**PREVOST**

**WARRANTY  
 BULLETIN**

Wb07-05

<b>DATE : JUNE 2007</b>	<b>SECTION : 07 - Transmission</b>
<b>EXPIRATION: JUNE 2009</b>	
<b>SUBJECT : REMOVAL OF ZF TRANSMISSION NEUTRAL POSITION RELAY ON H3 MULTIPLEX VEHICLES</b>

## PART 1: MULTIPLEX COACHES EQUIPPED WITH FORMER ZF NEUTRAL RELAY

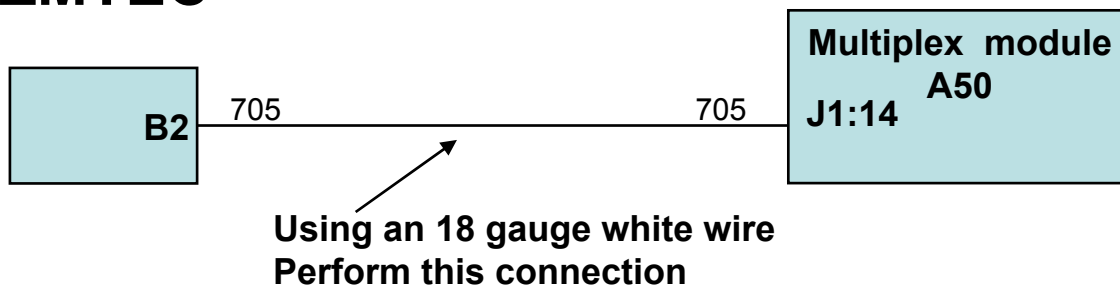
1. Remove ZF neutral relay located in the main power compartment near the ZMTEC module.
2. Locate wires 146A and 231 located near connector CV.
3. Cut both wires going to the ZF neutral relay and isolate using heat shrink tubing.
4. Remove wire 231Z from pin housing B2 of the ZMTEC module.
5. Crimp a socket terminal  (561604) at one end of an 18 gauge white wire, insert socket terminal into pin housing B2 of the ZMTEC module; crimp a socket terminal  (562806) at the other end of the wire, insert socket terminal into pin housing J1-14 of A50 multiplex module. Label wire 705.
6. Locate pin housing 21 in connector C717 and remove wire 231Z, isolate using heat shrink tubing.
7. Locate pin housing 15 in connector C717 and remove wire 121Z, isolate using heat shrink tubing.
8. Download multiplex program version P03.
